## **MCCOY OF SPRINGHILL SUBDIVISION**

### **RESUBDIVISION OF LOTS 1 & 2**

Engineering Comments: The following comments should be addressed prior to submitting the FINAL PLAT for acceptance and signature by the City Engineer:

## DETAIL SITE PLAN

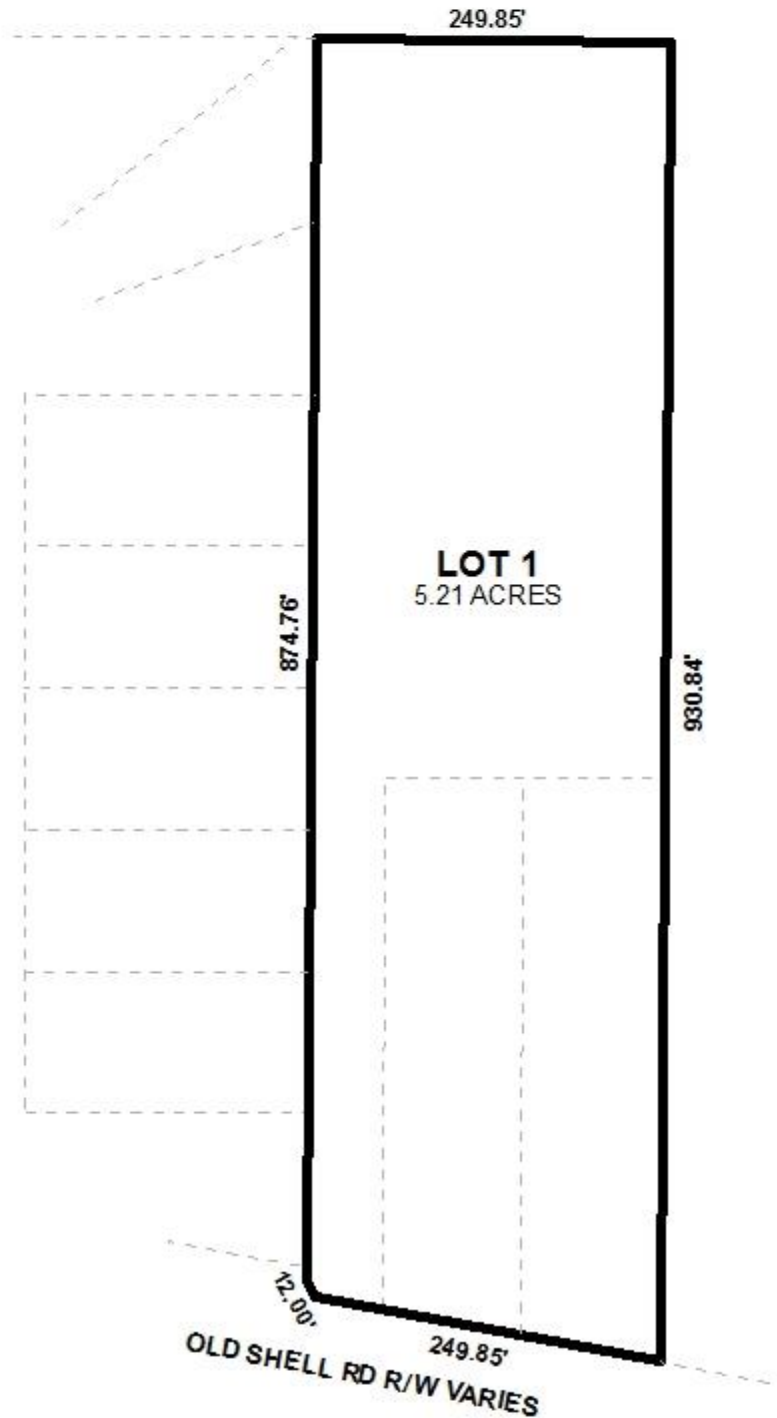
- B. Provide a correct Vicinity Map.
- C. Delete Pioneer Road from the Vicinity Map. There is no such road within the City of Mobile. Add Foreman Road and Dickens Ferry Road to the Vicinity Map.

- D. Check the bearings and distances shown in the boundary labels and description. Provide the record data for the north line, label the calculated bearing for the east line, and clarify whether record or calculated information is provided in the description for the south line along Old Shell Road.

- E. Provide and label the basis of bearing used for the survey.
- F. Provide the Surveyor's, Owner's (notarized), Planning Commission, and Traffic Engineering signatures.

The site fronts on Old Shell Road, a major street which should have a 100' right-of-way width. The preliminary plat illustrates Old Shell Road as having a right-of-way width that varies, possibly making dedication to provide 50' from the centerline necessary. If approved, this information should be indicated on the Final Plat. Additionally, as addressed by the original Subdivision Plat and as a means of access management, a note should be required on the Final Plat stating that the lot is limited to its two existing curb cuts, with any changes in their size, location and design to be approved by Traffic Engineering and conform to AASHTO standards.

The preliminary plat does not indicate the 35' building setback line for the proposed Lot as illustrated on the original Subdivision Plat, nor does it indicate the 25' minimum building setback line required by Section V.D.9. of the Subdivision Regulations. If approved, either the original 35' building setback line *or* the 25' minimum building setback line should be illustrated on the Final Plat.

The proposed Lot meets the minimum size requirements of the Subdivision Regulations and is labeled on the preliminary plat with its respective size in acres, but not in square feet. If approved, the lot size should be placed in square feet and acres on the Final Plat, or a table should be furnished on the Final Plat providing the same information.

- 1) application for and completion of the re-zoning process to create a single zoning district prior to signing of the Final Plat;
- 2) revision of the Final Plat to illustrate the existing minimum right-of-way width, and if less than 100', dedication to provide 50' from the centerline of Old Shell Road;

- 3) placement of a note on the Final Plat stating that the lot is limited to the two existing curb cuts to Old Shell Road, with their size, location and design to be approved by Traffic Engineering and conform to AASHTO standards;

- 4) illustration of either the 25' minimum building setback line, adjusted for right-of-way dedication if necessary;
- 5) provision of the lot size in square feet and acres on the Final Plat, or the furnishing of a table on the Final Plat providing the same information, adjusted for right-of-way dedication if necessary;
